Service Bulletin

Bulletin No.: 24-NA-106

Subject: Malfunction Indicator Lamp (MIL) Illuminated – DTCs P00C6, P312B, P217D, P2149, P312C, P01BF, P2CA0, P216D, P2155, P228C, and/or U101C Set

This Service Bulletin replaces PIE0780A. Please discard PIE0780A.

6657948

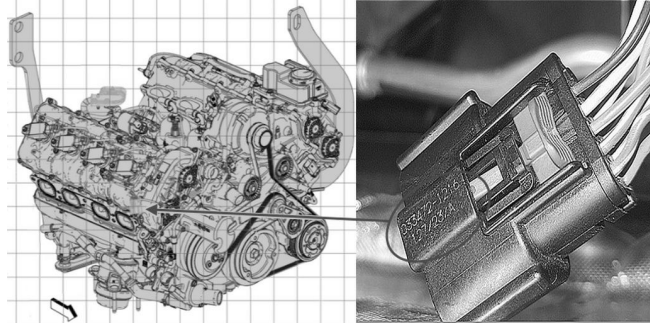
Cause	This condition may be caused by an incorrect 12-way in-line connector which leads to the bank 2 fuel rail assembly. This connector may have an open cavity allowing water intrusion into the fuel injector wiring harness.

Inspect the 12-way in-line electrical connector at the Fuel Injector Wiring Harness - Bank 2:

- If the connector part number 33472-1216 is on the connector as shown in the graphic above, that is the correct connector. Refer to the applicable DTC in service information for further diagnosis and repair.
- If the connector part number **IS NOT** 33472-1216, then it will be necessary to replace the engine harness, engine harness bracket (if applicable), fuel rail pressure sensor, and the fuel injection wiring harness.
